SECTION 00 9111
ADDENDUM NUMBER 01

DATE: August 19, 2024

PROJECT: S-29 Miller Armory Latrine Addition

PROJECT NUMBER: 2112209640

A101

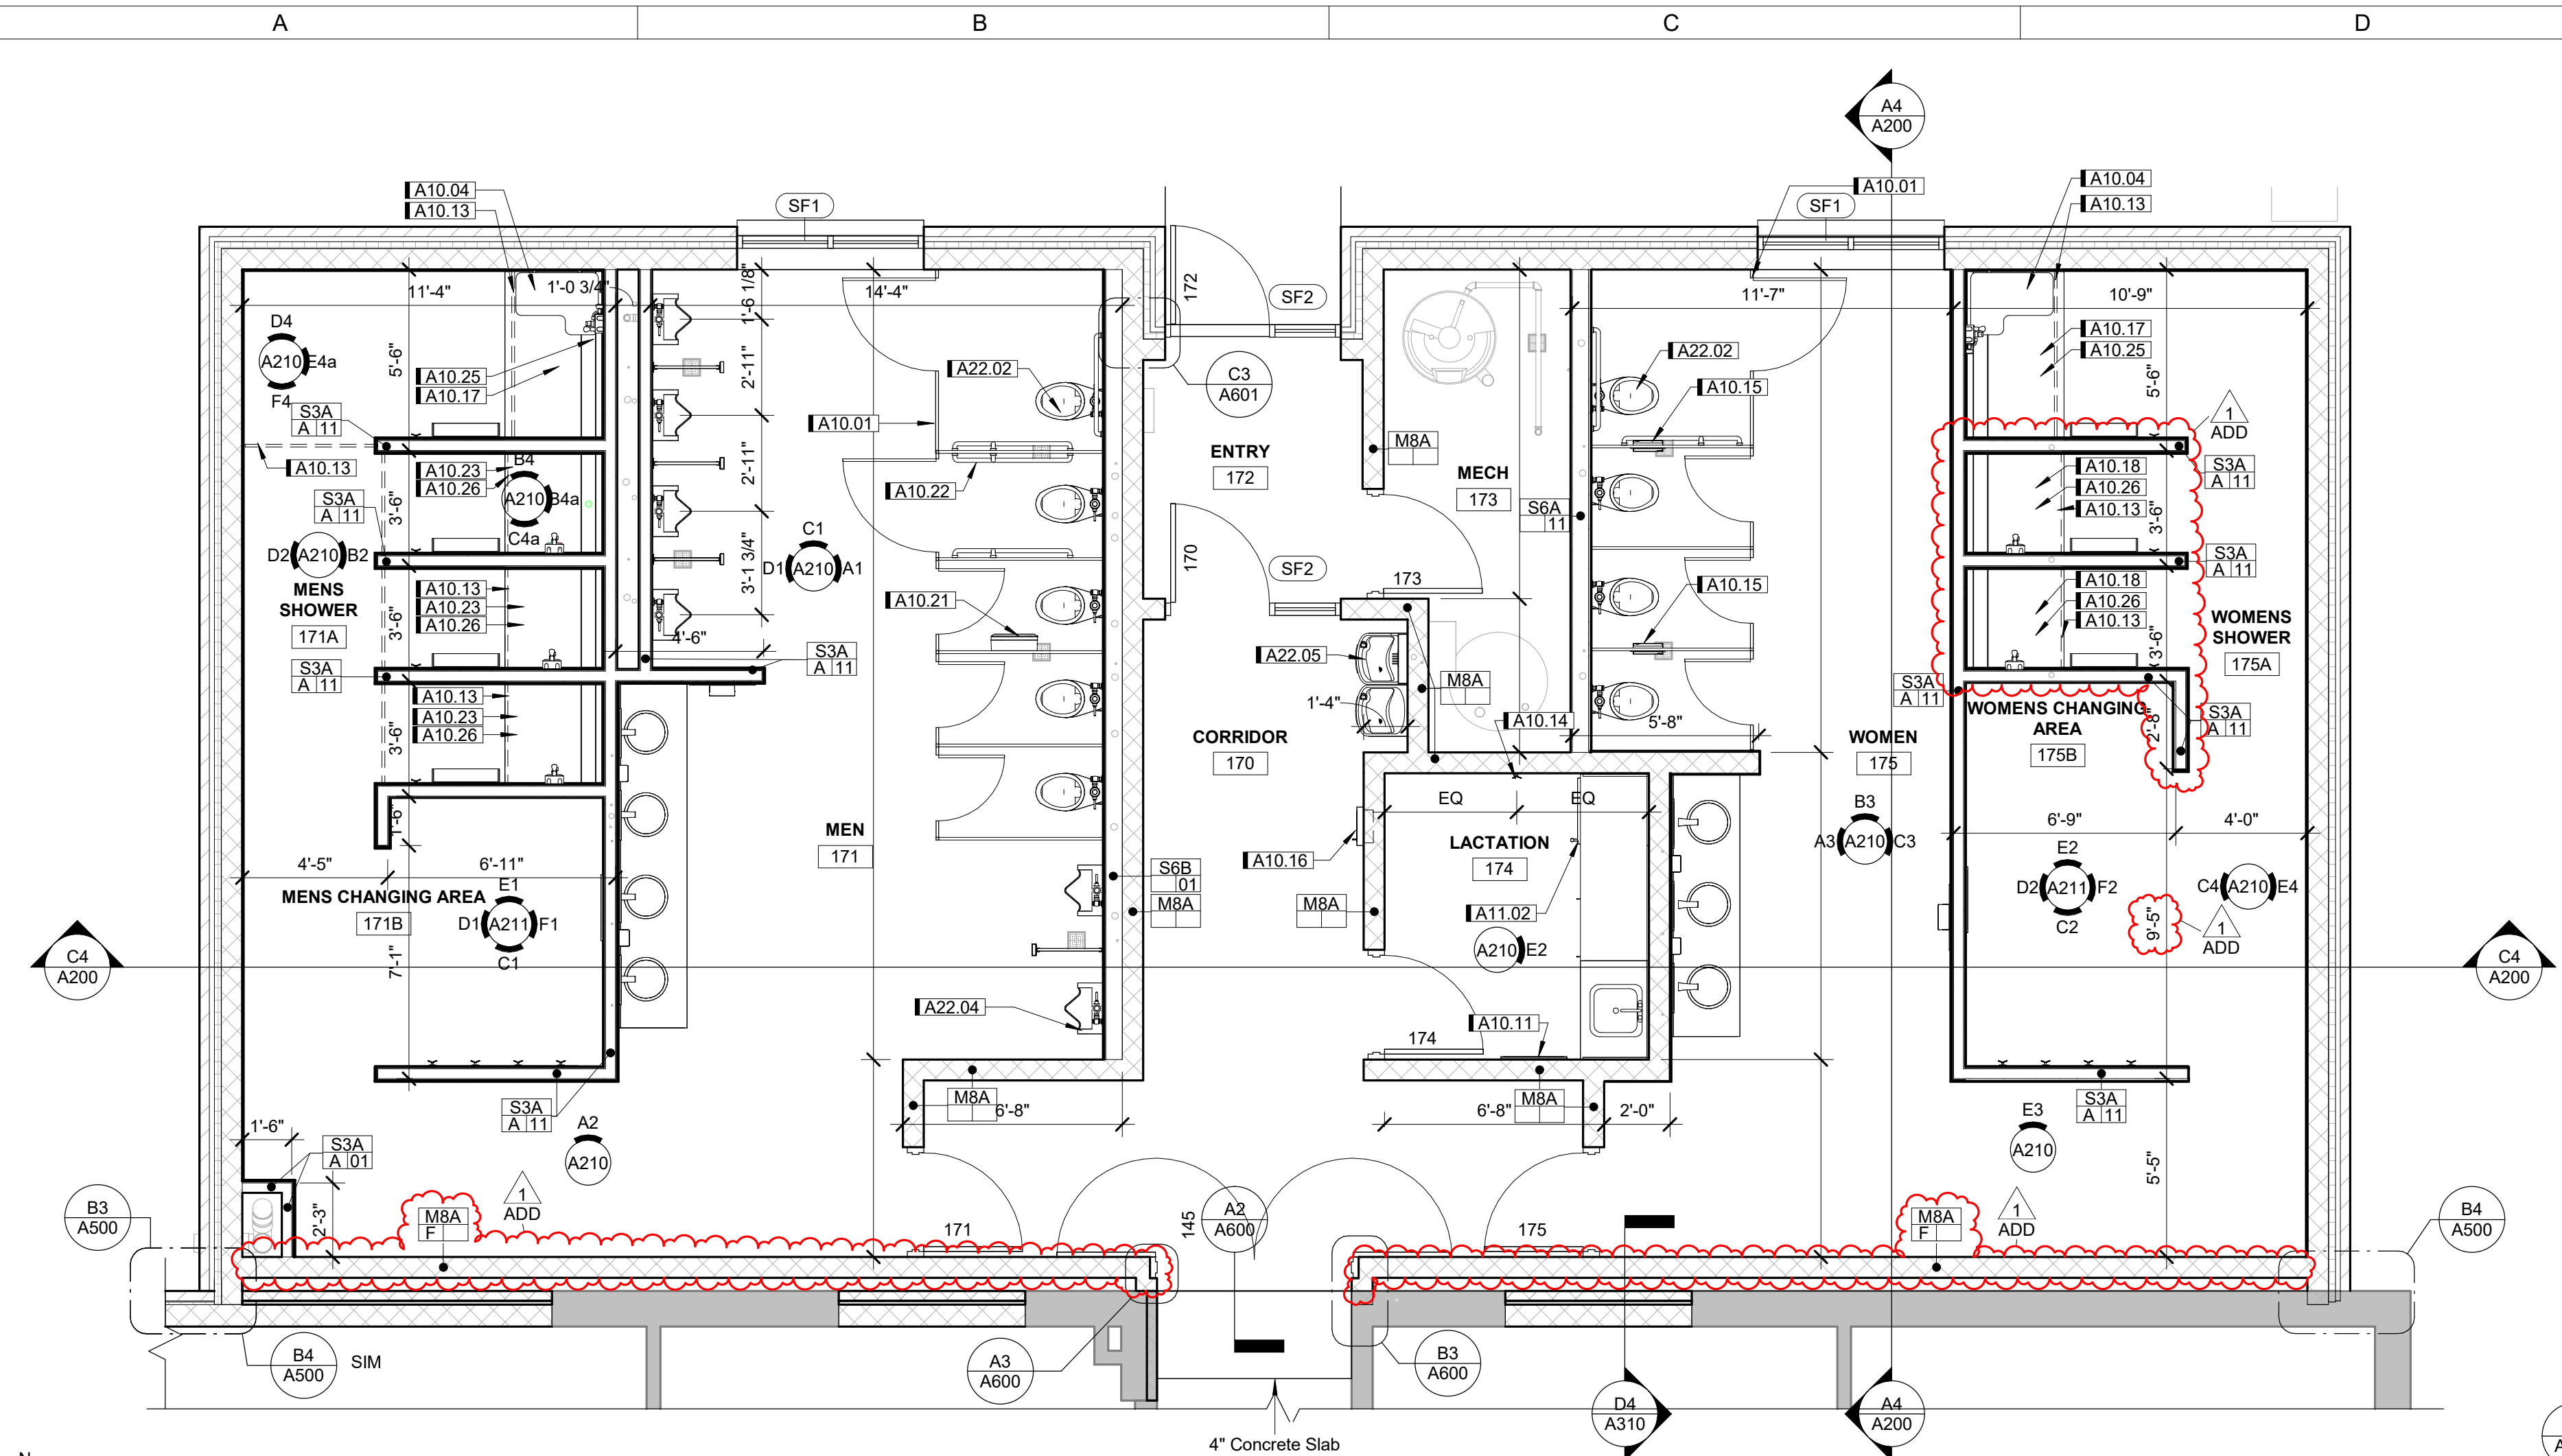
1. FLOOR PLAN A3: **REVISE** “Women’s Shower #175A, shower base from (44” x36”) to (36”x36”) and shift walls to match revised shower base.”
2. FLOOR PLAN A3: **REVISE** “Wall tag, for plan south CMU wall, to indicate 2 HR. fire rating.”
3. FLOOR PLAN C4: **REVISE** “Women’s shower #175A, Plan updated.”
4. KEYNOTE SCHEDULE: **REVISE** “Remove keynote A10.24.”

A2 ENLARGED FFE PLAN
 1/4" = 1'-0" 0 6'

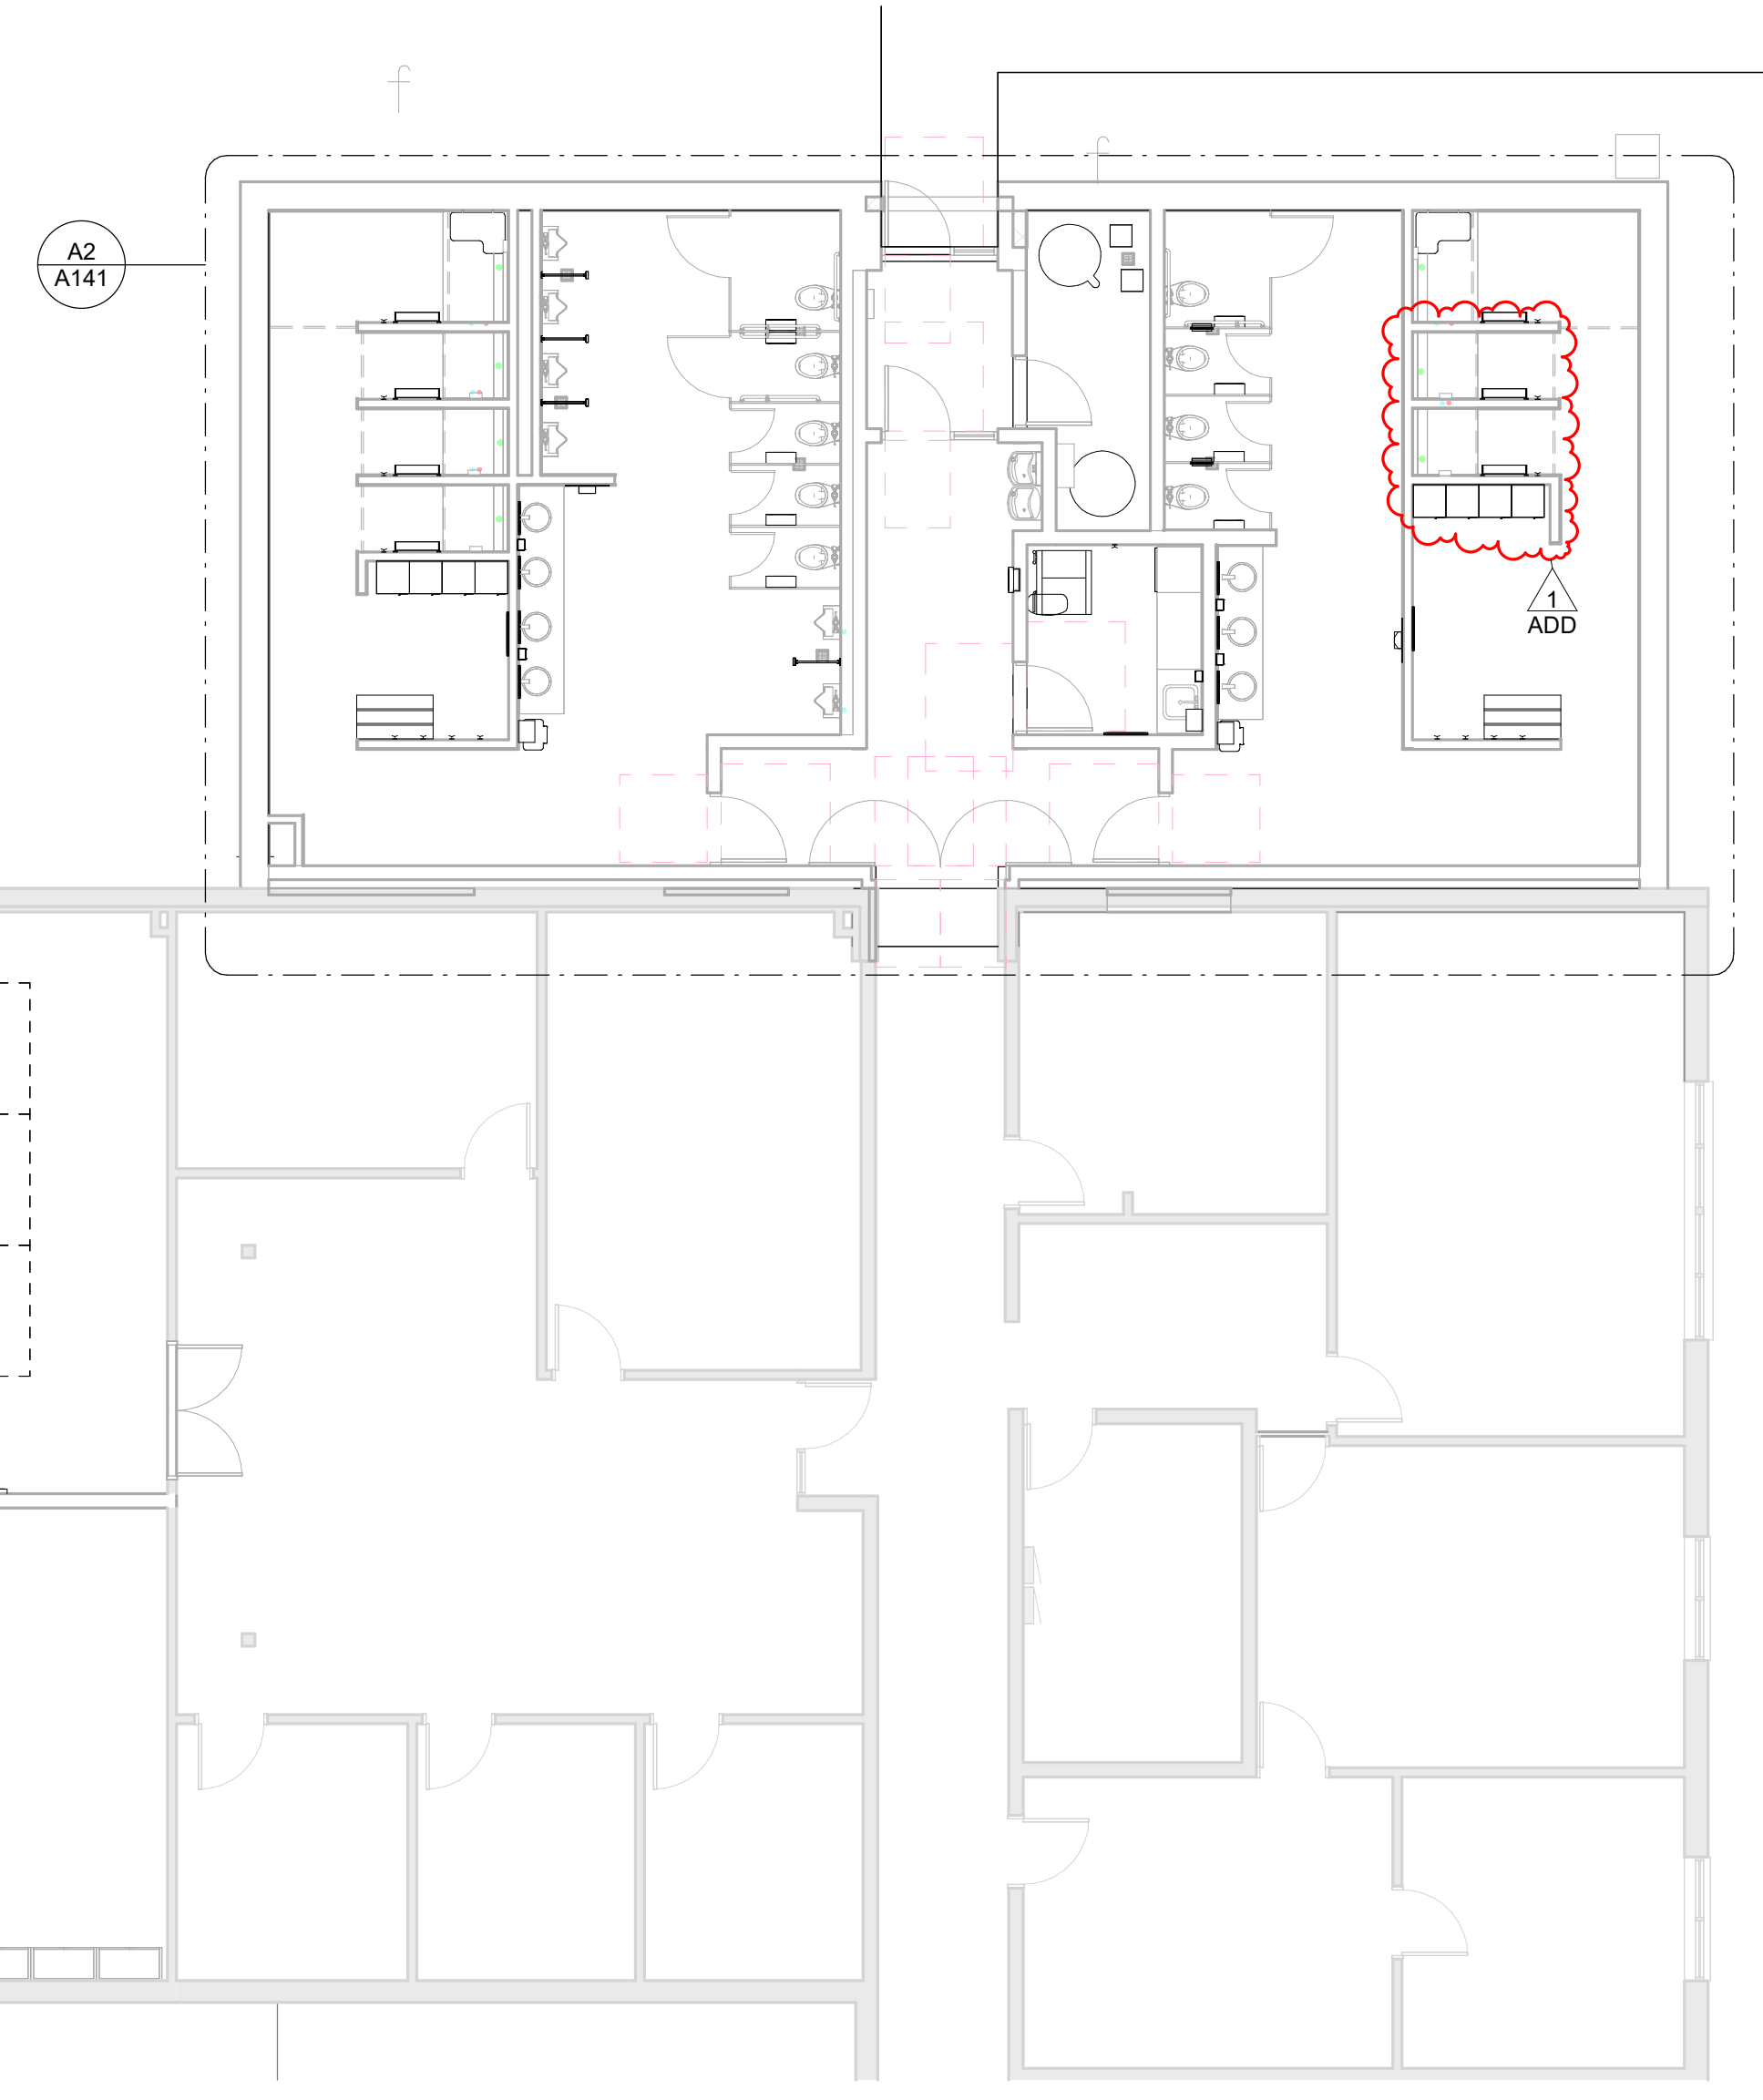
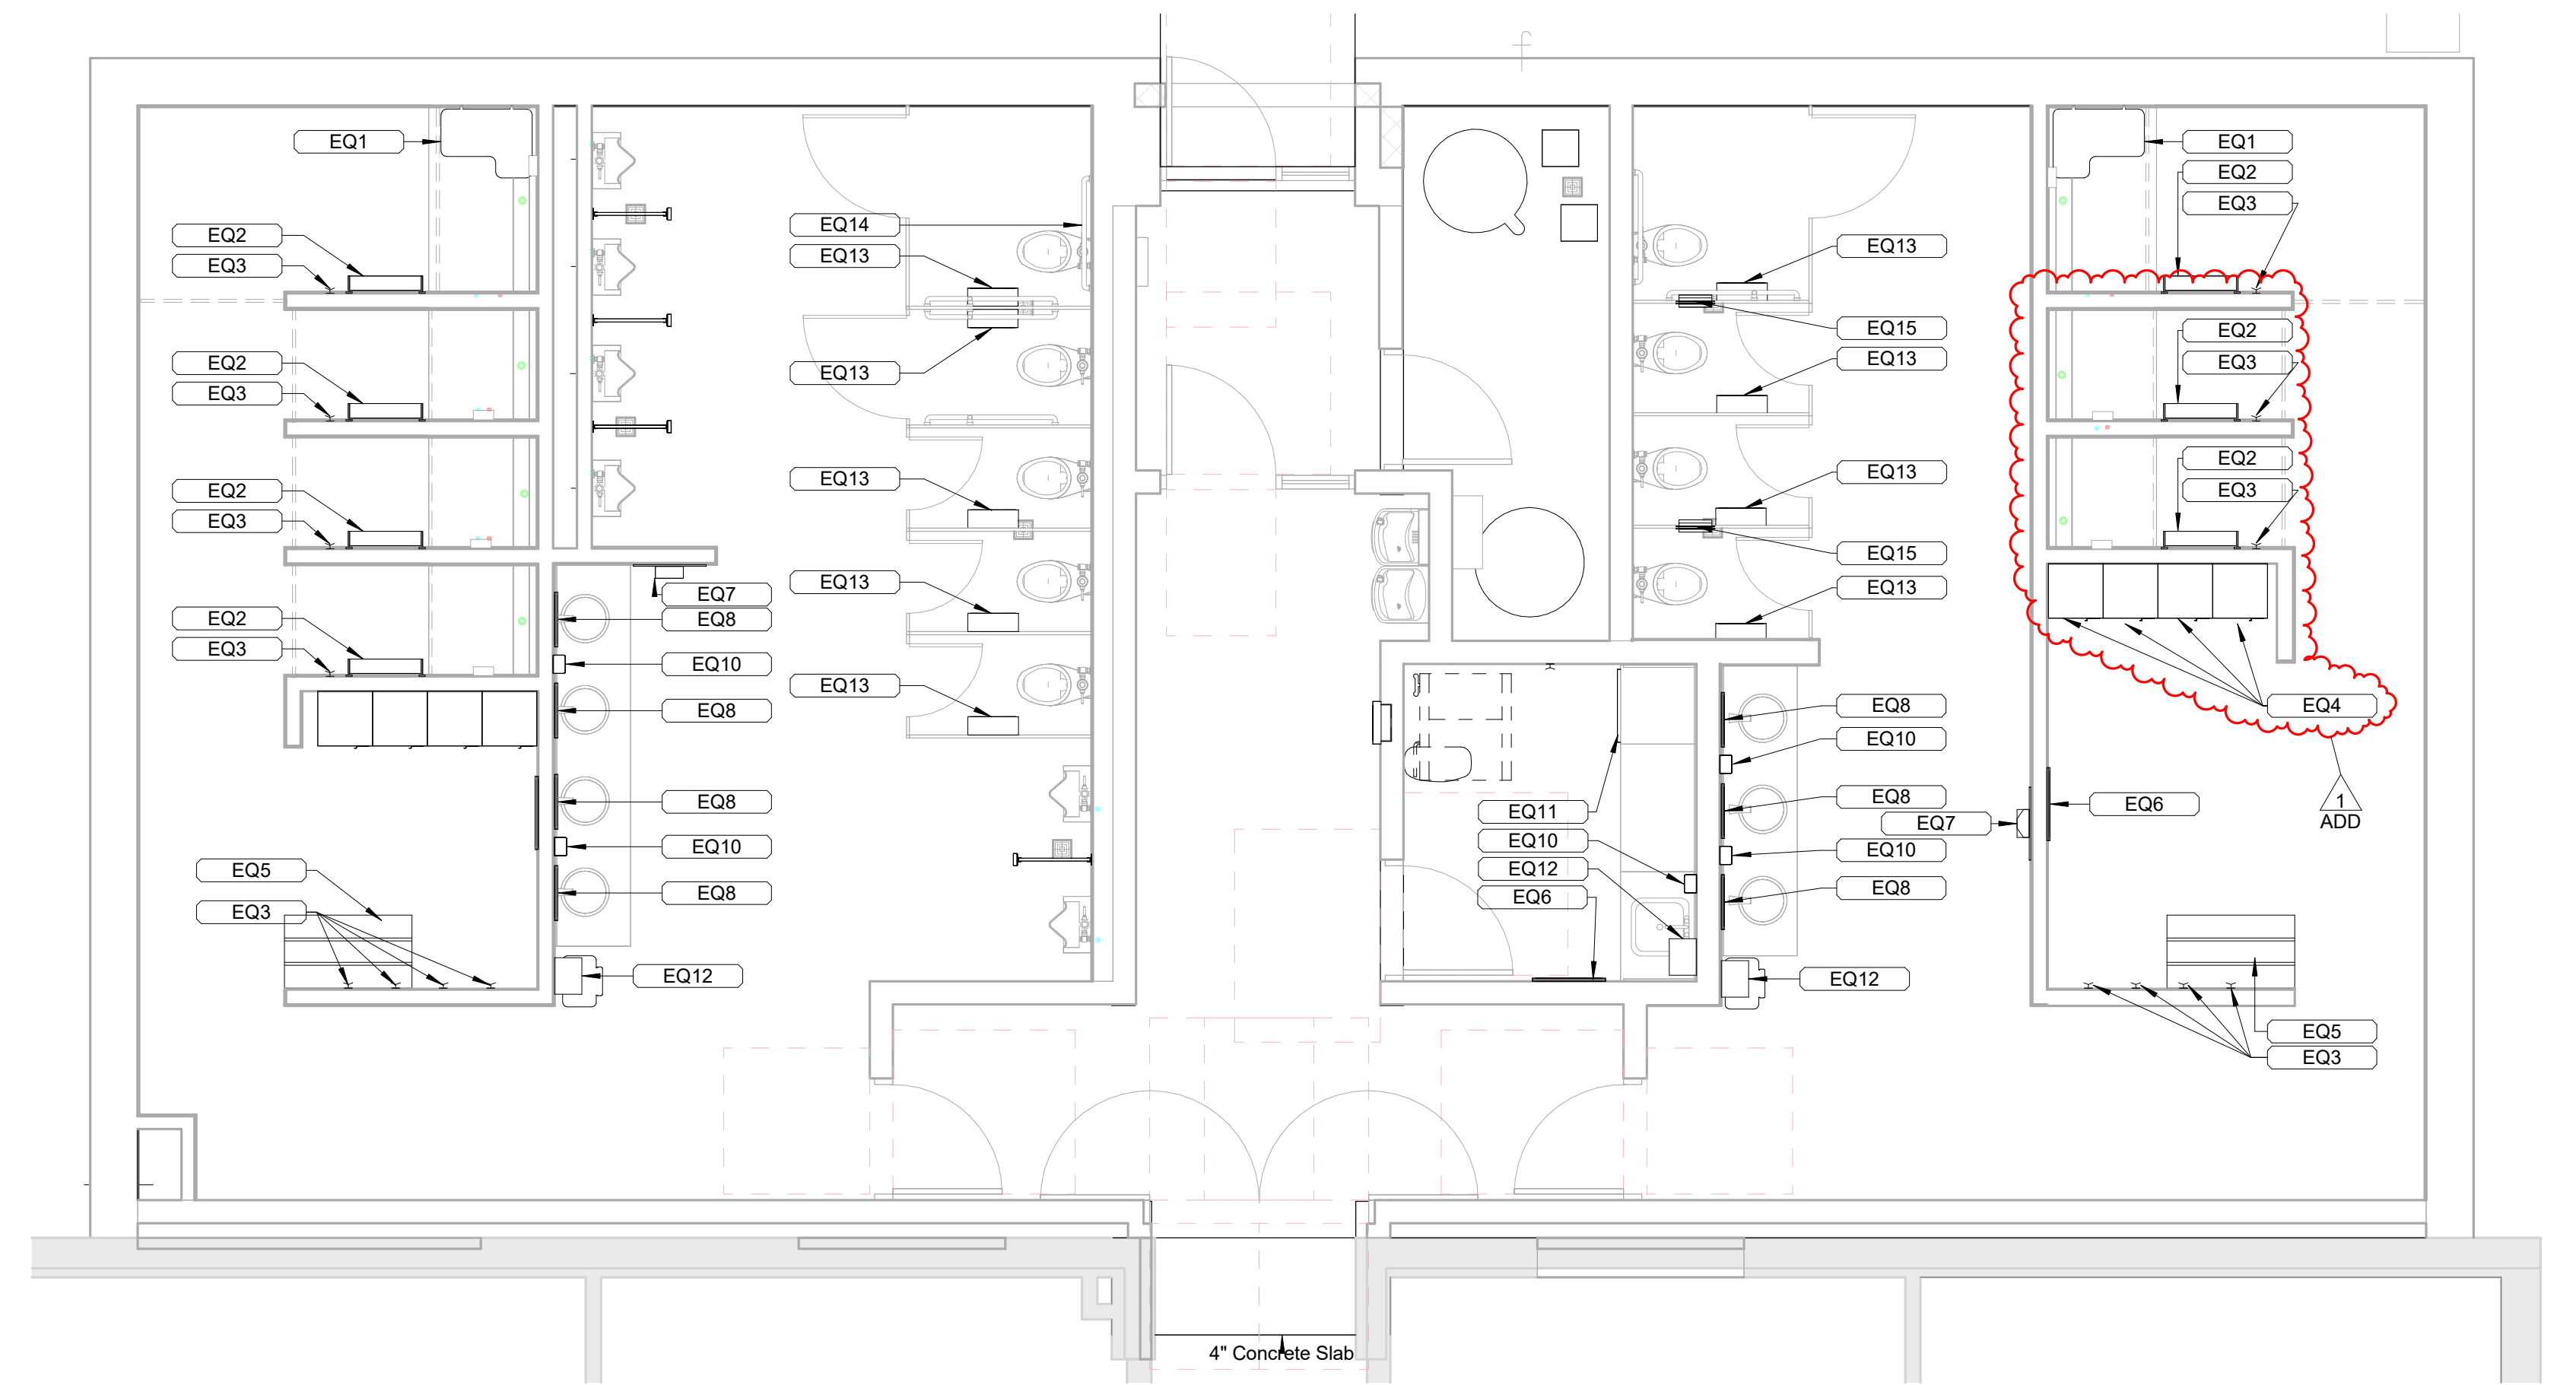
1. FLOOR PLAN A2: **REVISE** “Women’s shower #175A, Plan and Equipment updated.”

B4 TYP NON-ADA SHOWER
1/4" = 1'-0" 0' 6'

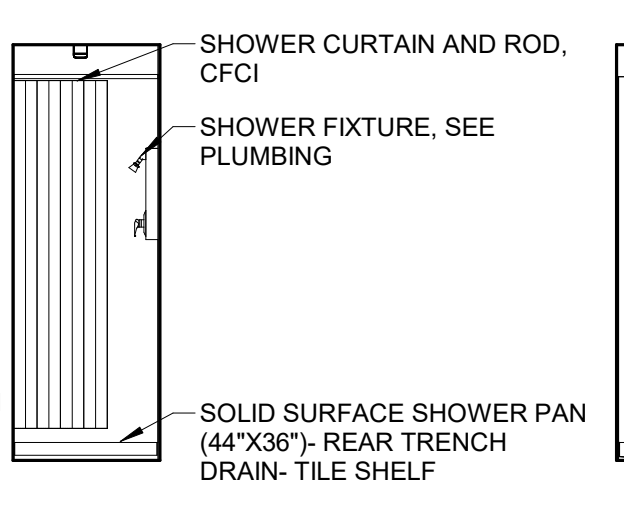
9. **Q:** The S-29 project needs a clarification on the type of sinks. At plan detail B4/A211 it calls out integral sinks (SS1), but on Plumbing Fixture Schedule on P600 it calls out Elkay Gourmet Lustertone series compartment undermount sink. Which is correct?

1. DETAIL B4: **REVISE** sink note to read: “stainless steel sink, refer to plumbing.”

A: *Contractor shall proceed with the stainless-steel sink by Elkay.*
